Subject: Open Items Associated with Walsh/Doyle Allegations Texas Utilities Generating Company Comanche Peak Steam Electric Station Independent Assessment Program, Phase 3 Job No. 84042

PHASES 1,2 AND 3 OPEN ITEMS LIST

FIGURE 1

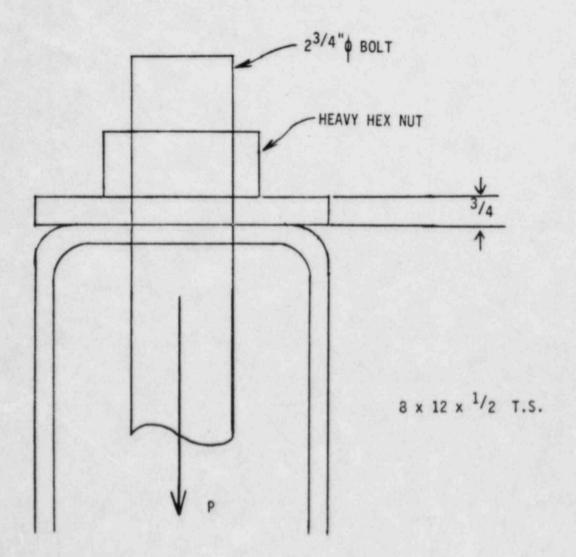
DESCRIPTION	CYGNA CROSS-REFERENCE	STATUS	RESPONSE DATE
4.	Punching effects in tube steel around bolt holes. (See Figure 1.)	IAP Phase 4 review open item.	Cygna reviewing TUGCO response to Cygna questions on the local effect in the tubesteel wall (TUGCO letter dated 11/8/84).	Letter to TUGCO summa- rizing Cygna concerns scheduled for 1/25/85.
